PG&E Letter DCL-20-063

Diablo Canyon Units 1 and 2 Docket No. 50-275, OL-DPR-80 Docket No. 50-323, OL-DPR-82 <u>License Amendment Request 20-02,</u> <u>Non-Voluntary License Amendment Request to Revise Technical Specifications</u> <u>3.2.1, F_Q(Z), to Implement Methodology from WCAP-17661, Revision 1, "Improved</u> <u>RAOC and CAOC F_Q Surveillance Technical Specifications"</u>

License Amendment Request 20-02, Non-Voluntary License Amendment Request to Revise Technical Specifications 3.2.1, $F_Q(Z)$, to Implement Methodology from WCAP-17661, Revision 1, "Improved RAOC and CAOC F_Q Surveillance Technical Specifications"

LCO 3.2.1 $F_Q(Z)$, as approximated by $F_Q^C(Z)$ and $F_Q^w(Z)$, shall be within the limits specified in the COLR.

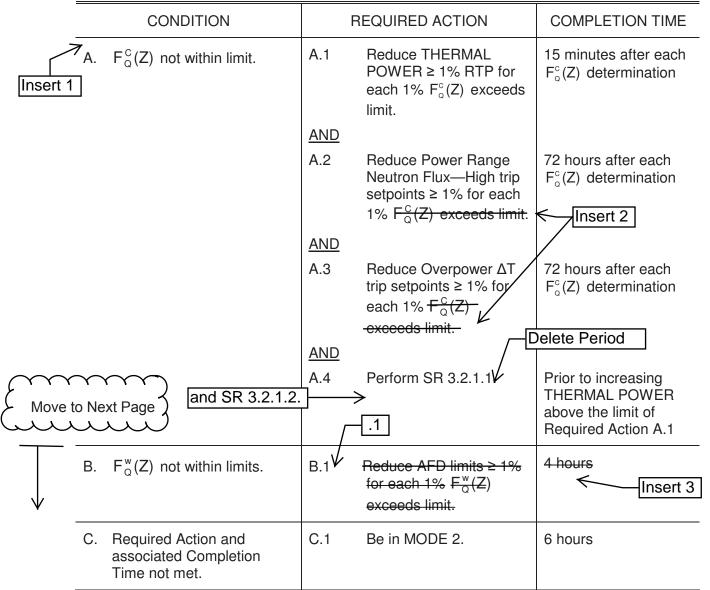
Move to Next Page) E REQUIREMENTS	Delete	F _Q (Z) 3.2.1
	scalation following shutdown, The revel has been achieved, at w	IERMAL POWER may be i	
	SURVEILLANCE		FREQUENCY
SR 3.2.1.1	Verify $F^{C}_{Q}(Z)$ is within limit.		Once after each refueling prior to THERMAL POWER exceeding 75% RTP
			AND
